SR - 700 American Boulevard
SCHEMATIC DESIGN | LAND USE APPLICATION

SR - 700 American
700 W AMERICAN BLVD / BLOOMINGTON, MN

PRELIMINARY
NOT FOR CONSTRUCTION
SCHEMATIC DESIGN
CITY SUBMITTAL
10.11.2023
REVISIONS

LANDSCAPE PLAN

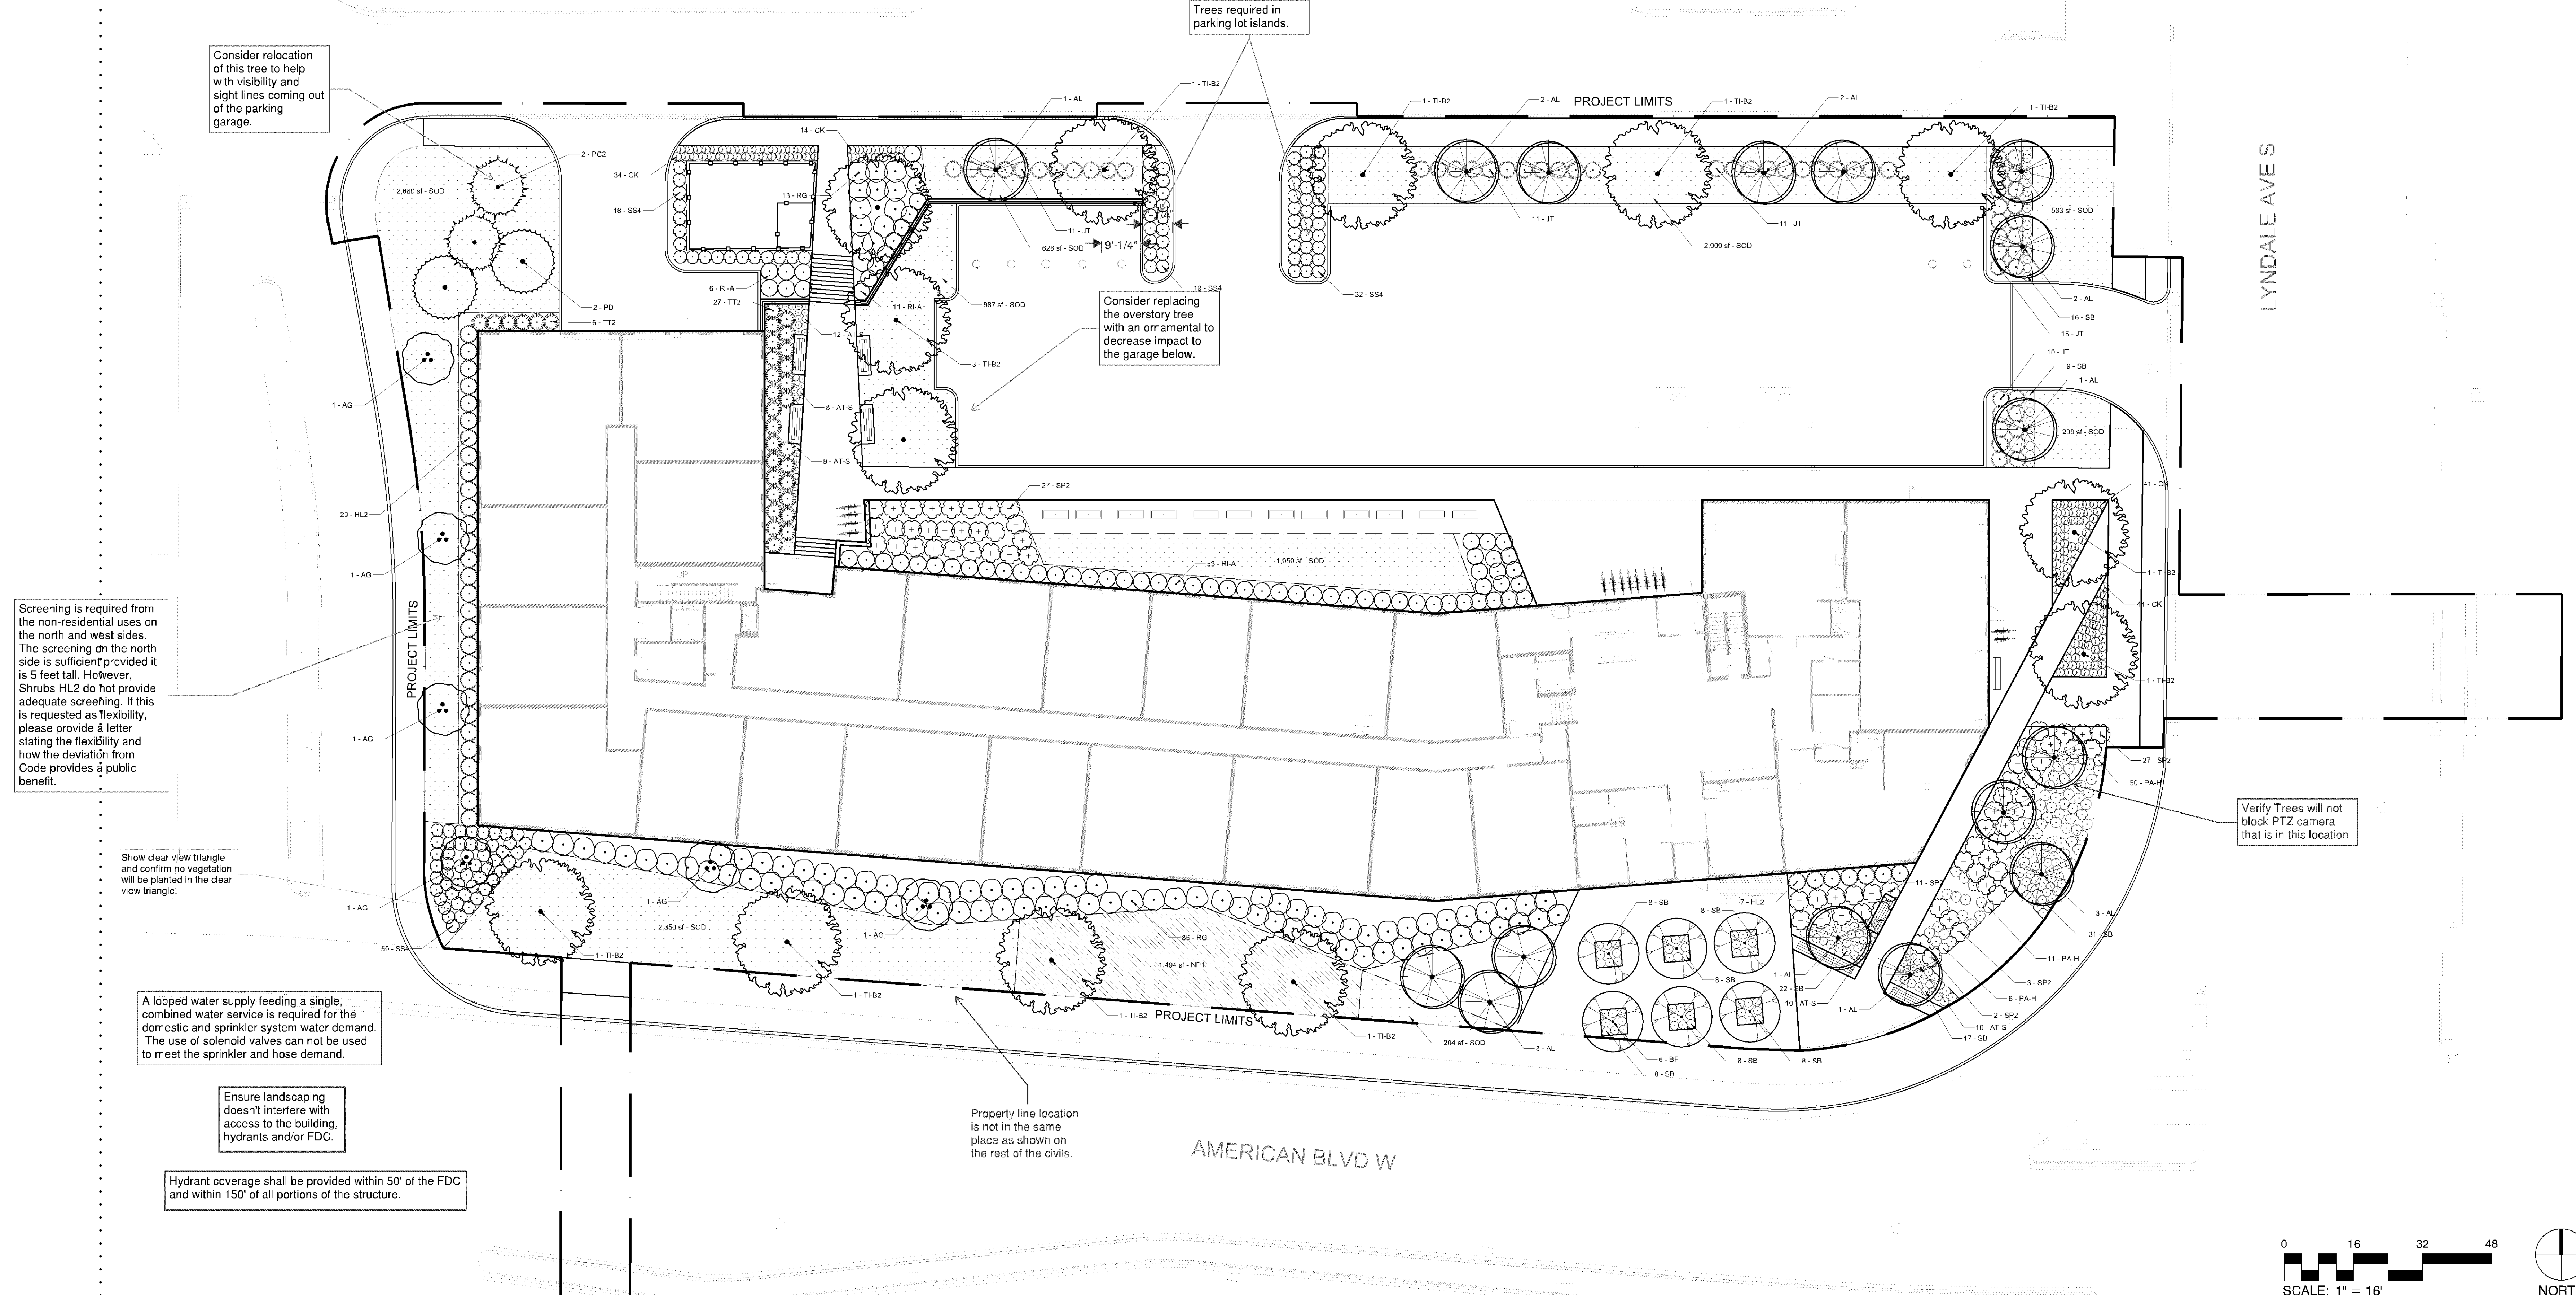
Consider relocation of this tree to help with visibility and sight lines coming out of the parking garage.

Screening is required from the non-residential uses on the north and west sides. The screening on the north side is sufficient provided it is 5 feet tall. However, Shrubs HL2 do not provide adequate screening. If this is requested as flexibility, please provide a letter stating the flexibility and how the deviation from Code provides a public benefit.

Show clear view triangle and confirm no vegetation will be planted in the clear view triangle.

Ensure landscaping doesn't interfere with access to the building, hydrants and/or FDC.

Hydrant coverage shall be provided within 50' of the FDC and within 150' of all portions of the structure.

Trees required in parking lot islands.

Consider replacing the overstory tree with an ornamental to decrease impact to the garage below.

Verify Trees will not block PTZ camera that is in this location

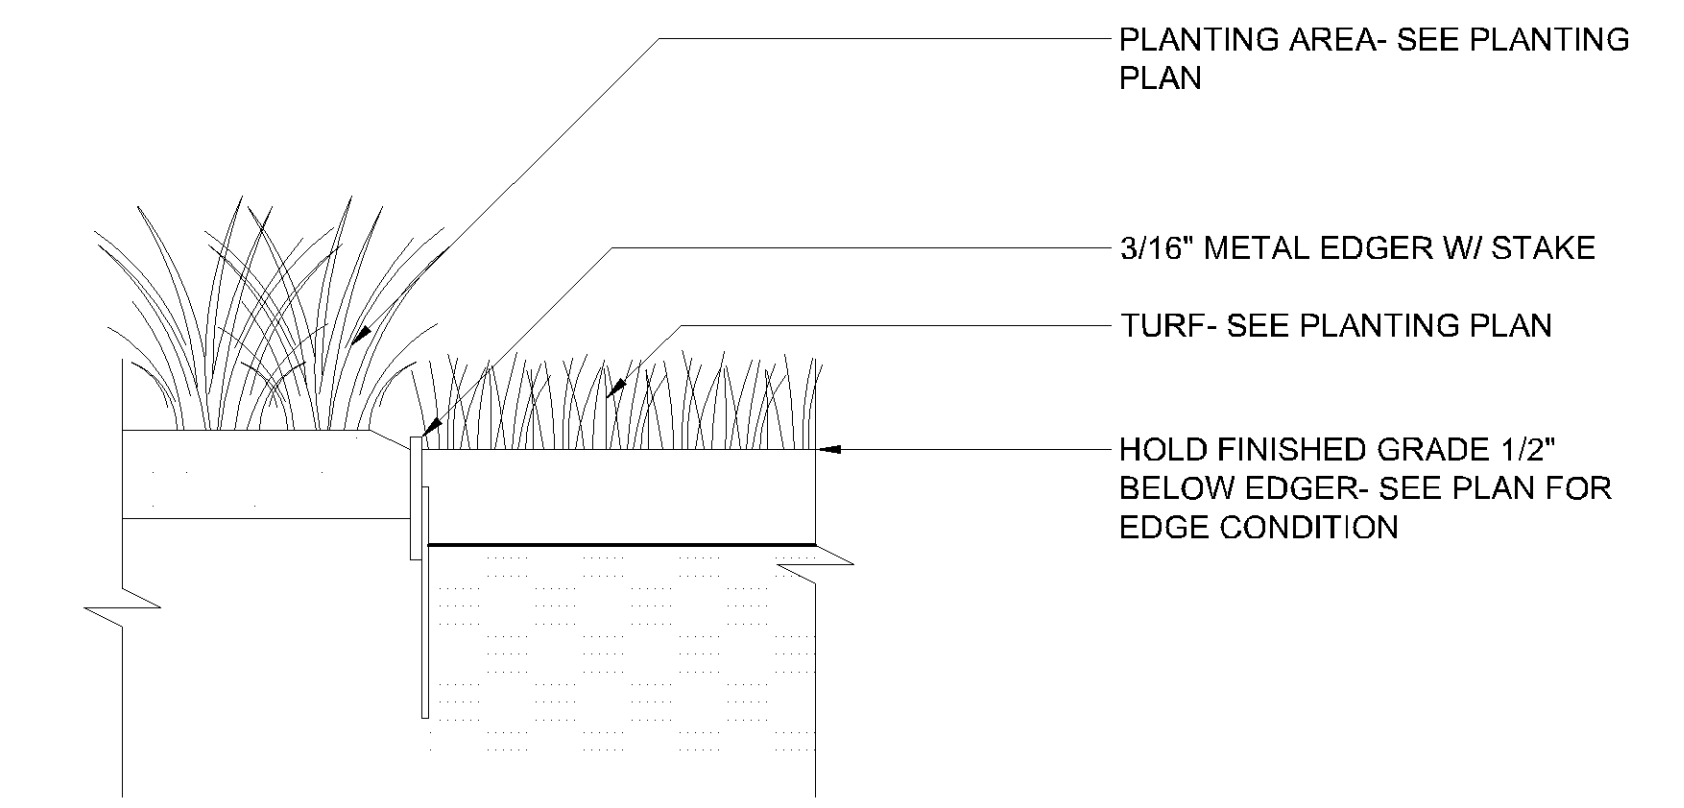
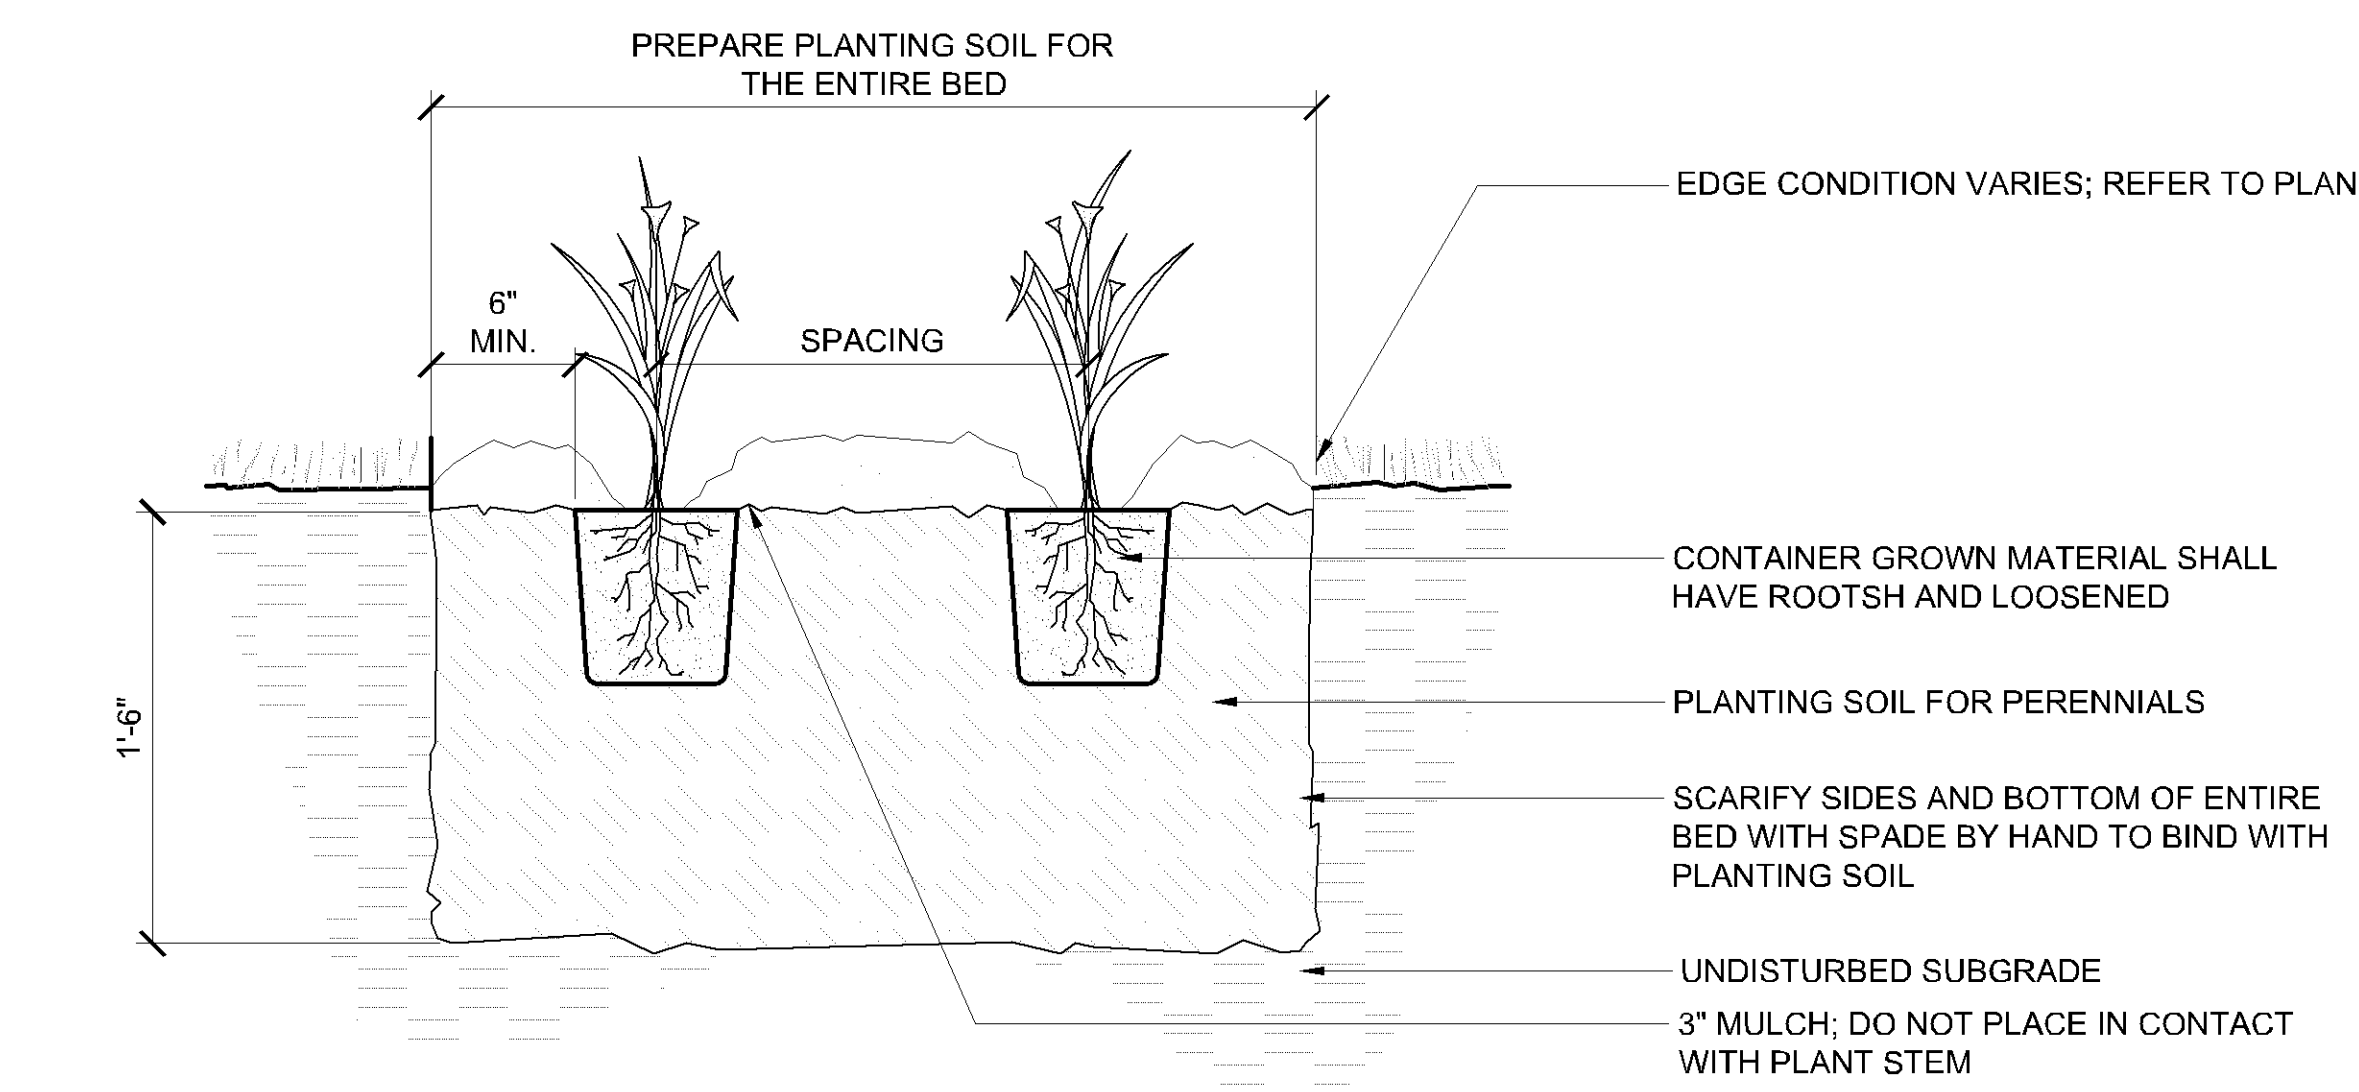
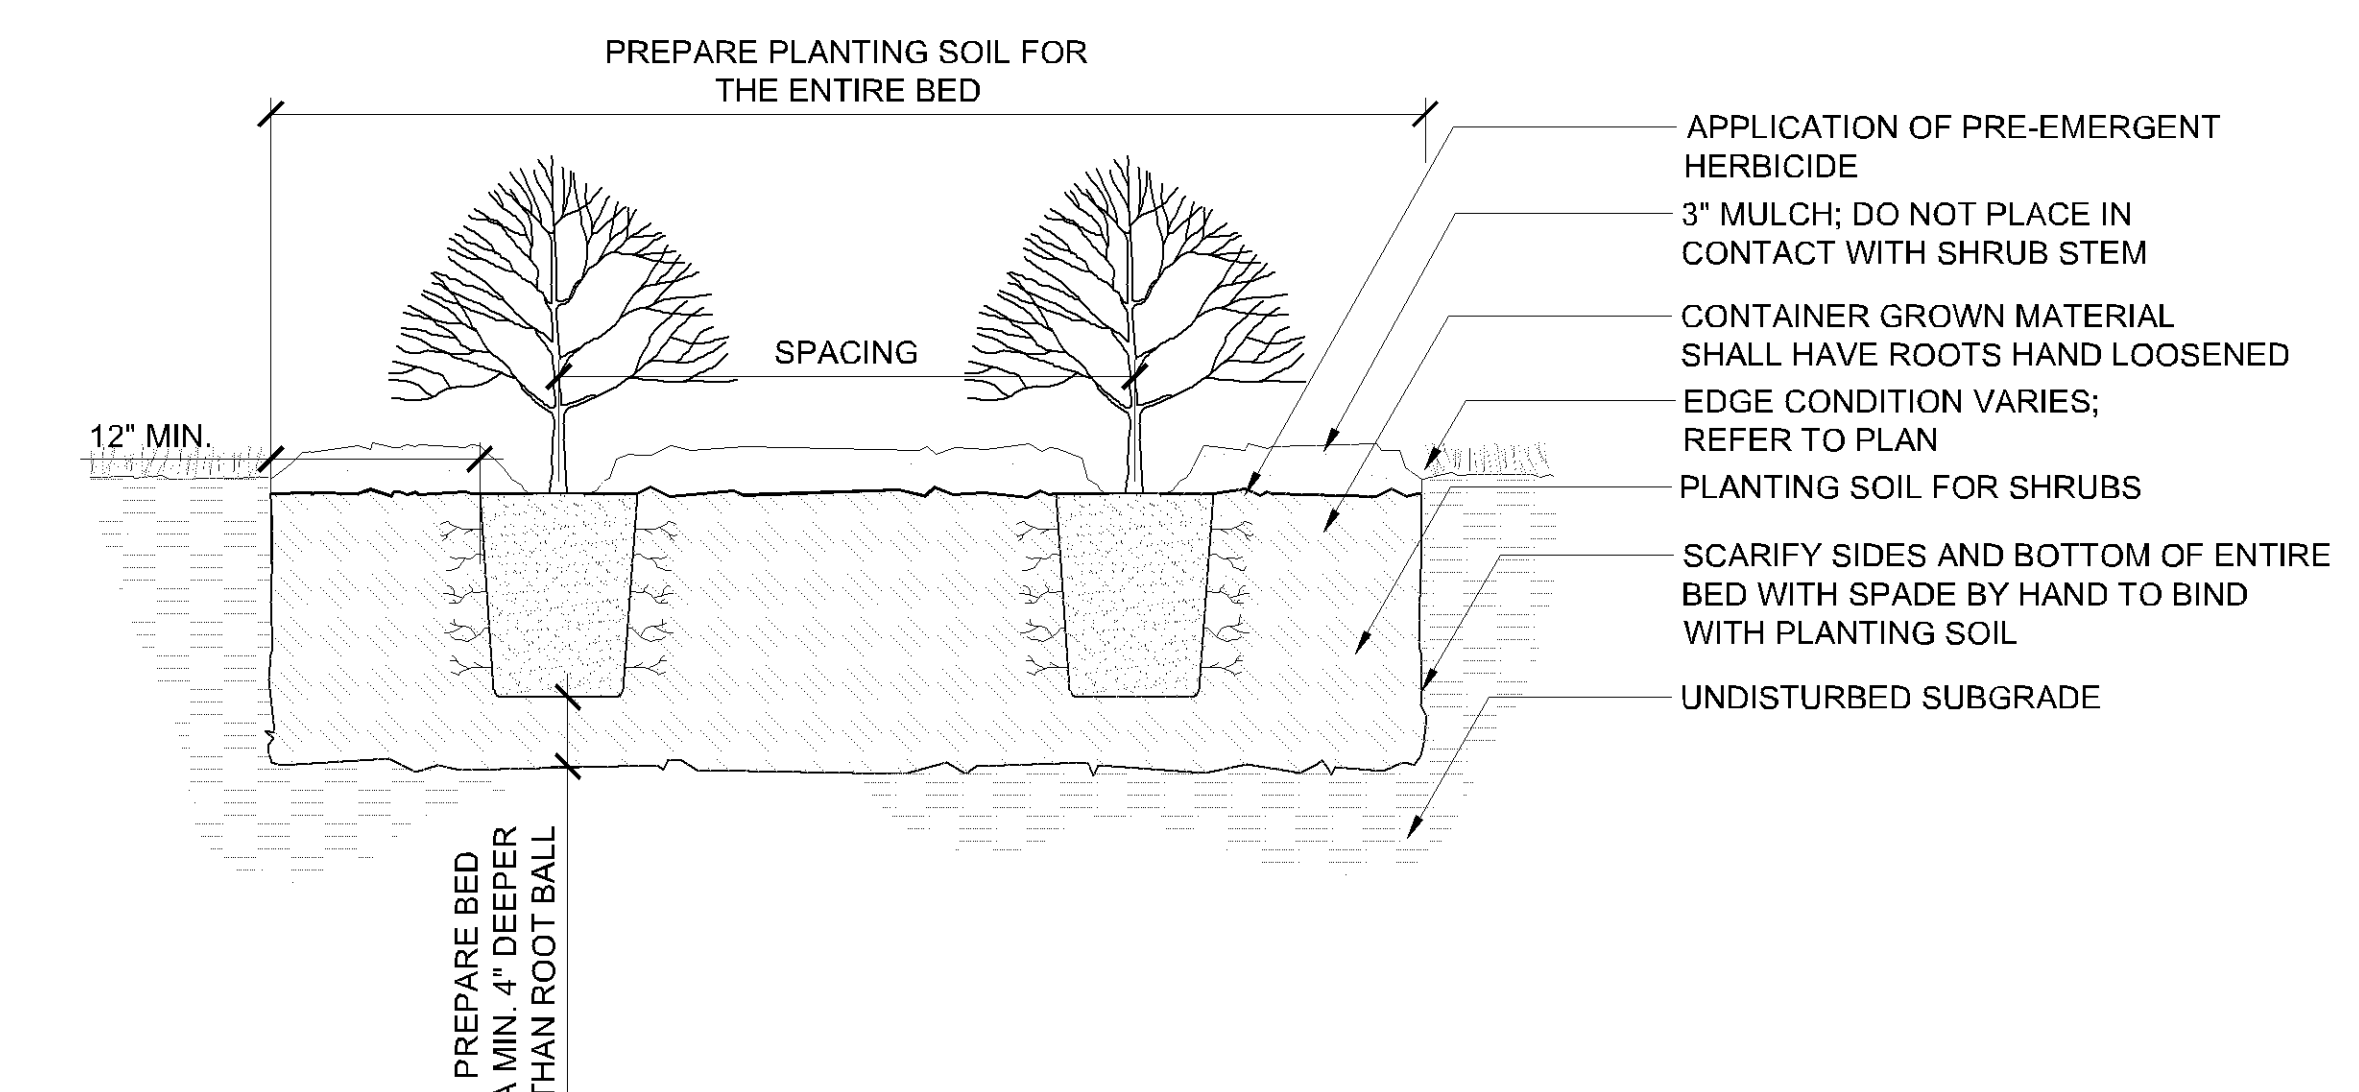
bike rack detail not included - Site plan references this sheet for bike rack detail
